RE: RED ROOF INN (Mulberry St SE) (M-15/D33)
CERTIFICATE OF OCCUPANCY APPROVAL-*Temporary*
ENGINEERS STAMP DATED 3/9/2000
ENGINEERS CERTIFICATION DATED 6/20/2001

Re: Red Roof Inn – Kirtland Addition Drainage Report
Engineer's Stamp dated 8-30-00 (M15/D33)

DRAINAGE REPORT

Red Roof Inn

DEVELOPED BASIN LAYOUT

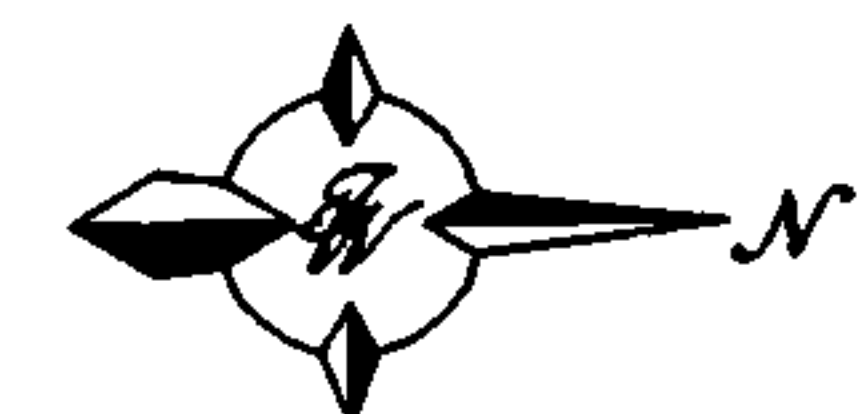
4' on plan
